### Delegated officer report for planning application

**Application no.** 142746/NMC/2025

**Proposal:** Non material amendment application to planning approval reference 140400/JO/2024 to allow the following amendments: Reduction in the extent of the canopy over the main entrance; adjustment to transom height of the first-floor windows; amendment to include a flat bricked detail to the soffit at the head of the curtain walling; removal of plant enclosure to roof; and, correction to plans to show stair core for consistency across the approved drawings

**Address:** Withington Community Hospital, Nell Lane, Manchester, M20 2LR

02 / Approach from Burton Road Entrance (Revised)

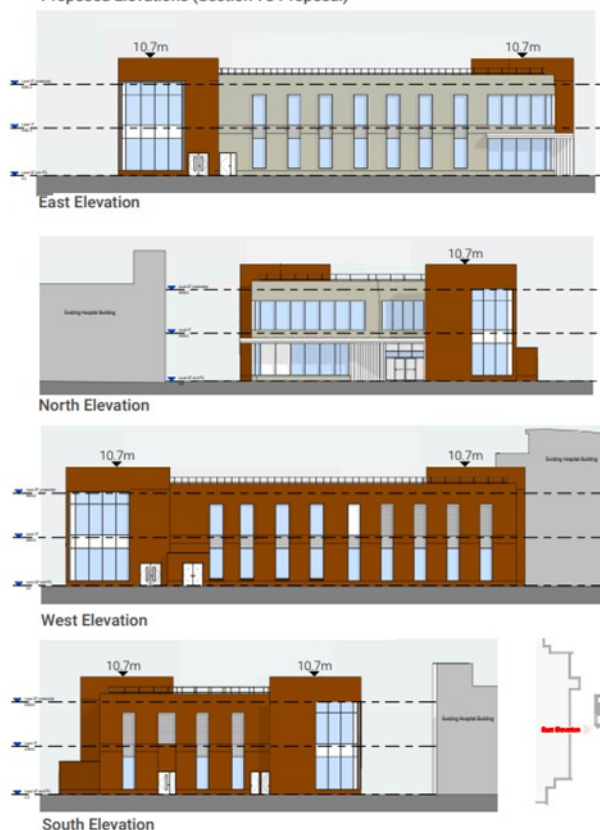
- Removal of canopy above main entrance and implementation of more localised canopy over entrance door.
- Adjustment to transom height of the first floor windows to match the internal ceiling level. This results in the spandrel panel zone being larger (the raked ceiling has been retained to the GF waiting area to retain window heights)
- The stepped brick soffit at the head of the curtain walling of the stair cores at the corners of the building have been removed.
- Amends to elevation plans to remove dotted line relating to 'plant enclosure' which is no longer required based upon the plant and equipment to be installed.
- Amends to elevation plans to show stair core, as shown on the previously approved section plans, this amendment is required as a procedural measure to ensure consistency.

Following an assessment of the amendments proposed it is considered that these are non-material in nature and as such the changes are not considered to materially alter the originally approved scheme, and would not give rise to impacts on the character of the area in which the site is located nor the adjacent Albert Park conservation area. As a result of these amendments an update to condition number 2 (specified plans) is required to refer to the updated plans.
